**CERTIFICATE OF APPROPRIATENESS**

**Property:** 1222 Rutland St, lot 22, tract 23A, block 184, Houston Heights Subdivision. The property includes a historic 1,090 square foot, one-story wood frame single-family residence and a detached garage situated on a 6,600 square foot (50' x 132') interior lot.

**Proposal:** New Construction – Construct an approximately 900 square foot detached, two-story alley-loading garage at the rear of the lot.  
See enclosed application materials and detailed project description on p. 4-13 for further details.

ROOF PLAN

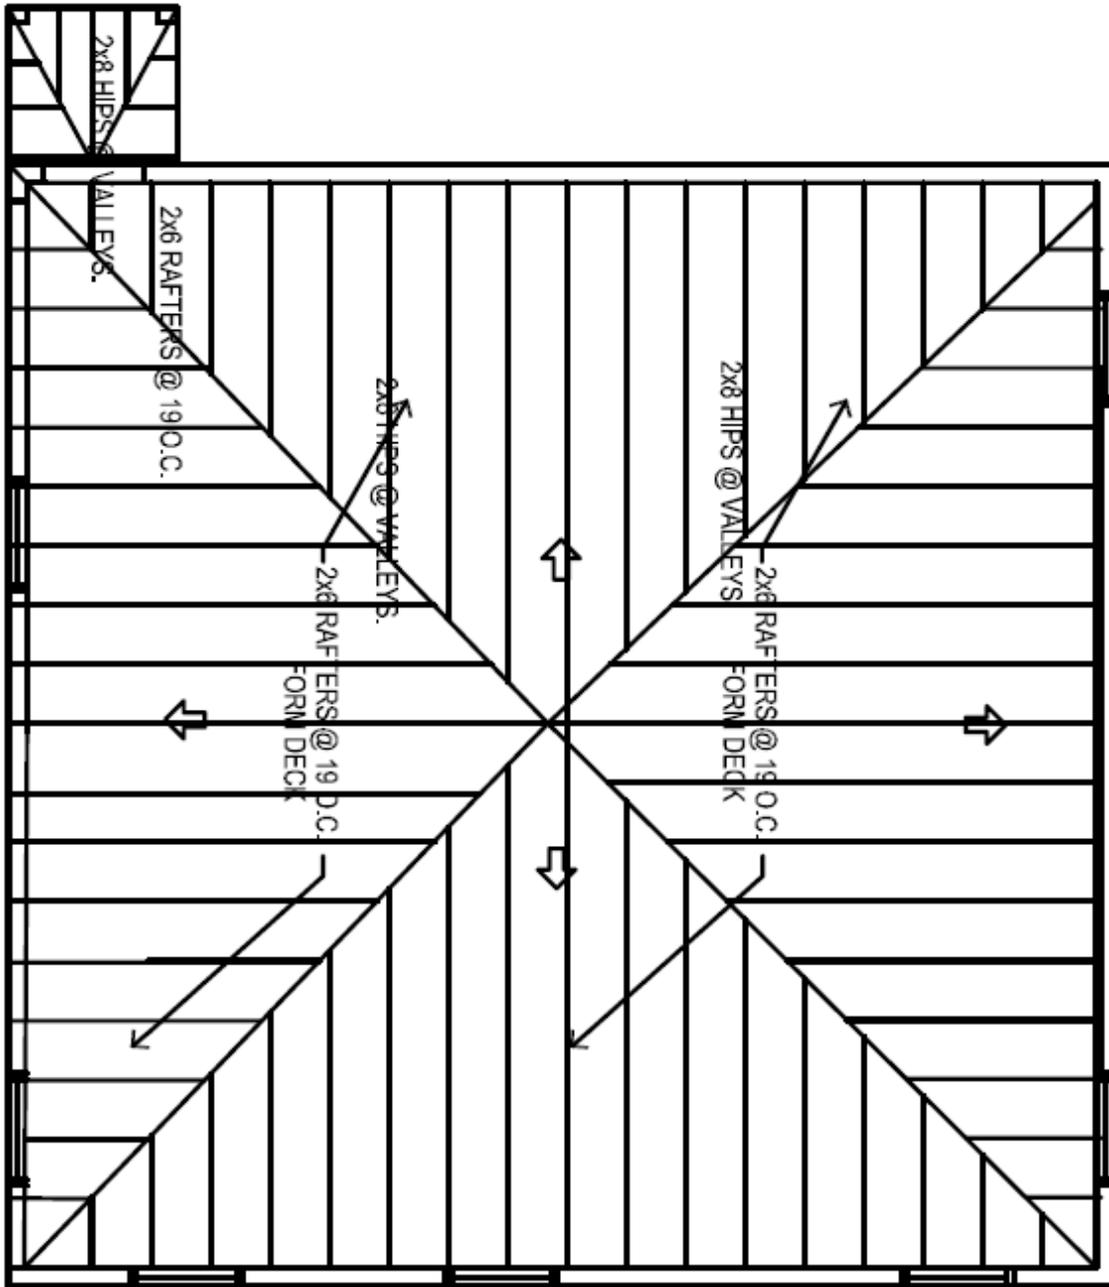
**Setbacks:** The garage is situated 98' from the front (west), 7' from the side (south) and 4'-6" from the rear (east) property lines.

I **SUPPORT** this application. The proposed visual design is simple with one-over-one lite windows and simple fenestration. I would recommend the applicant consider a minimum 9 foot setback from the alley to provide the minimum 24 feet un-obstructed backout space for an alley-loaded garage.
